MTF Performance Evaluation

Related to comments #365

HCB – Comment #365

CI 179B SC 179B.2.1 P 873 L 40 # 365

Figure 179B-1—Test fixtures reference insertion losses

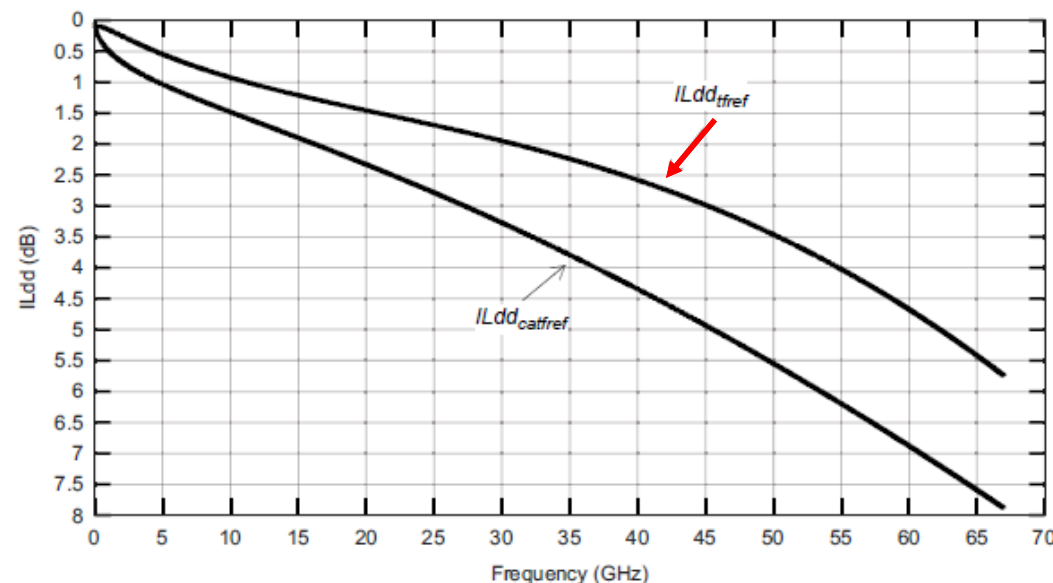
Equation 179B-1, as plotted in Figure 179B-1 does not seem to track the insertion loss profile of an actual test fixture.

Update Equation 179B-1 and Figure 179B-1 with a more representative profile. Contribution to follow at the September Interim.

PROPOSED ACCEPT IN PRINCIPLE.

Pending review of contribution kocsis_3dj_01_.2509.

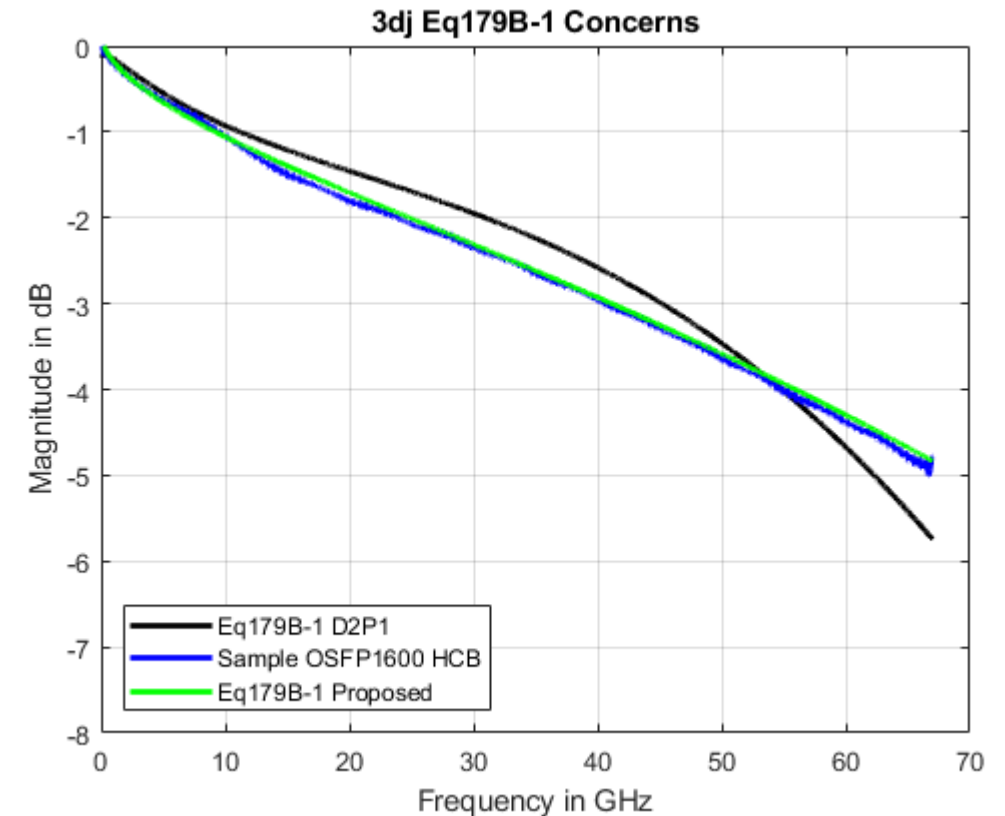
- Eq179B-1 D2P1
 - Plotted equation fixes coefficient errors, comment #444
- Sample OSFP1600 HCB (.s4p*)
 - 'OSFP1p6T_HCB-WT31053_TX3_Characterization_File_Corrected'
- Eq179B-1 Proposed

$$ILdd_{\text{tref}}(f) = -0.015 + 0.28\sqrt{f} + 0.03495f - 0.00495f^{1.5} + 0.00065f^2$$

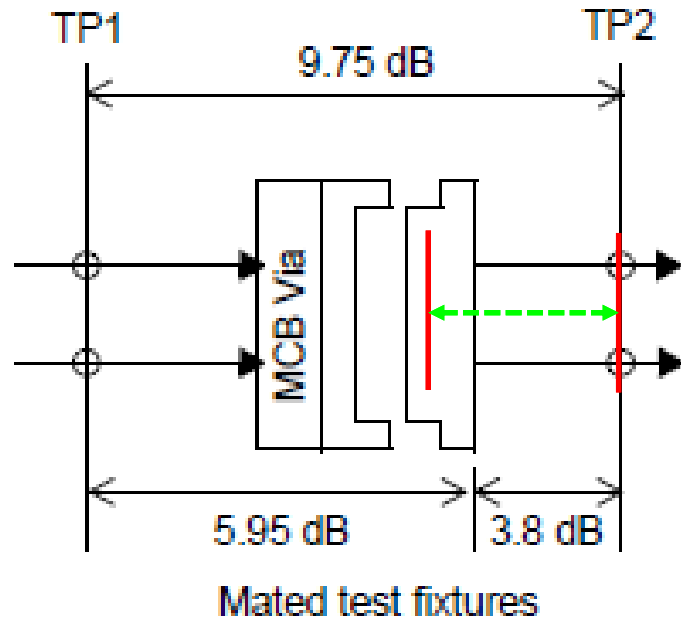
- Characterization file obtained from an open circuit measurement of the HCB, then post-processing converts the .s2p to an .s4p* file

- Adopt the equation proposed below for Eq179B-1

$$ILdd_{\text{tref}}(f) = -0.15 + 0.3\sqrt{f} + 0.0351f - 0.005f^{1.5} + 0.00065f^2$$
